January 18, 2013

Subject: ENERGY STAR® Lamps v1.0 Specification Draft 3

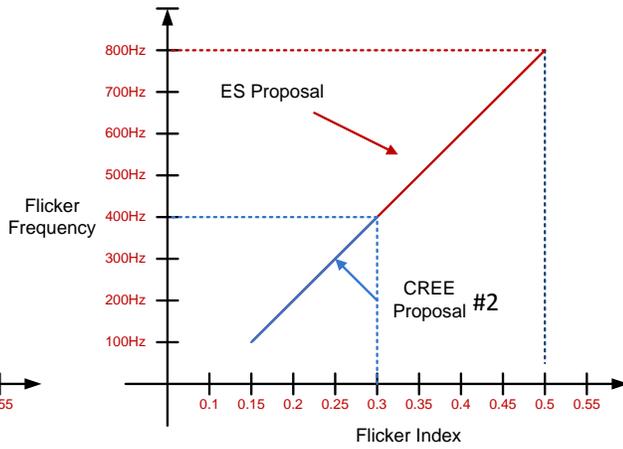
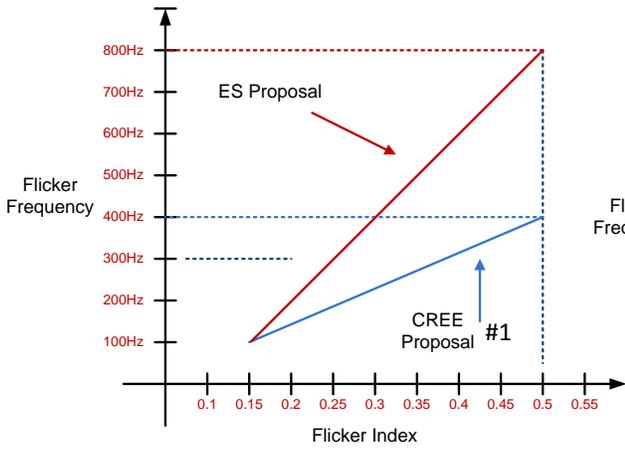
Maximum Light Output (Page 25): “rated” should be changed to “measured” in the following requirement: “Lamp light output on a dimmer/control shall not exceed the lamp’s **rated** light output by more than 10% or fall below the maximum light output by more than 20%”. The reasoning is that one would not want the tolerance to be a part of the variation so measuring the unit under test (UUT) and then applying this requirement is appropriate.

Freq	Index
ENERGY STAR[®] Proposed	100	0.15
	200	0.2
	300	0.25
	400	0.3
	500	0.35
	600	0.4
	700	0.45
	800	0.5
Frequency		120
Index		0.160

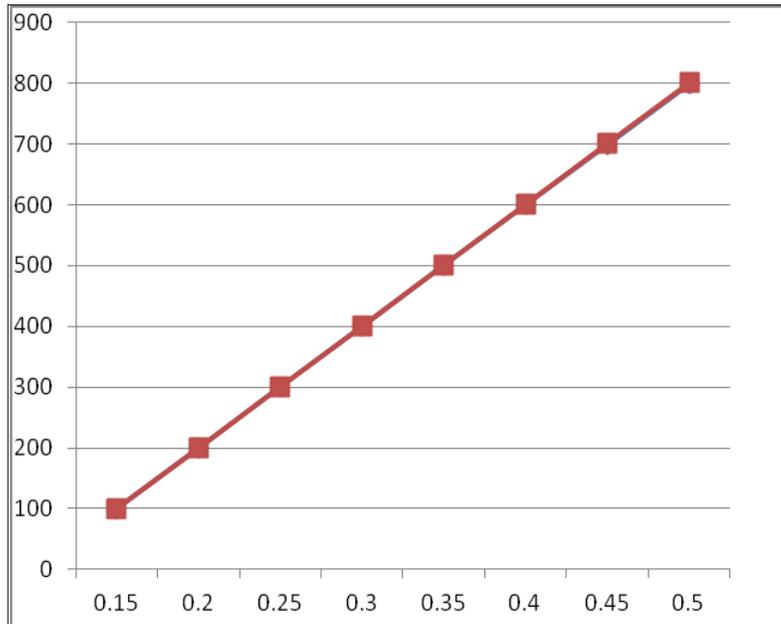
Flicker (Page 25): “Applies at full and dimmed measurement conditions.” At what conduction angle(s) will the lamp be tested at to verify this requirement?

The flicker allowable under the proposed guidelines would disallow PWM dimming below 800Hz though human perception of flicker is well below 200 Hz.

Freq	Index
CREE Proposed - Option #1	100	0.15
	200	0.266
	300	0.383
	400	0.5
Frequency		
	120	
Index		
	0.173

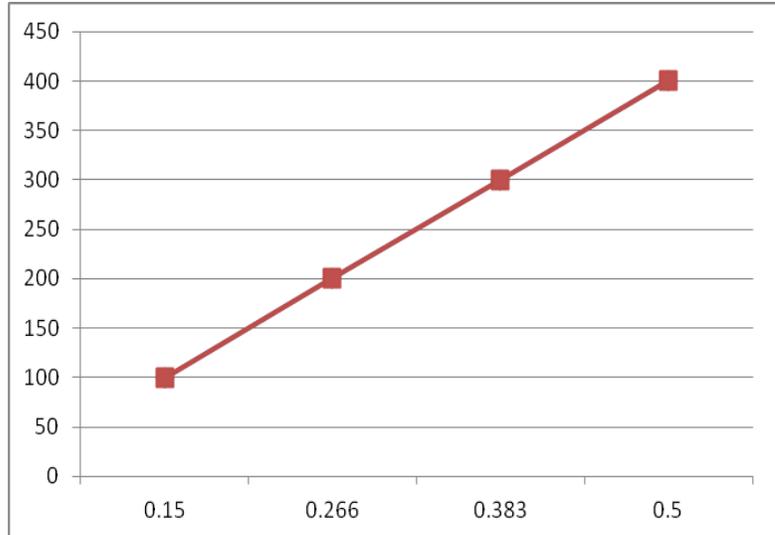
- Option #1: Reduce the frequency of testing to 100Hz – 400Hz. A flicker index of 0.50 would be the limit at 400Hz

Freq	Index
CREE Proposed - Option #2 Same as ES proposal but stops at 400Hz	100	0.15
	200	0.2
	300	0.25
	400	0.3
Frequency		
	120	
Index		
	0.160

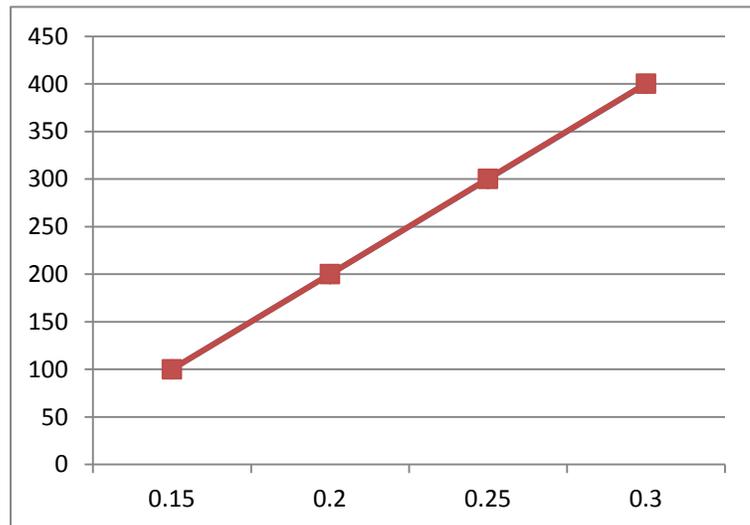
- Option #2: Keep the proposed slope of the original guideline, but reduce the maximum frequency of testing to 400Hz. Therefore at 400Hz, the maximum flicker index allowed is about 0.275
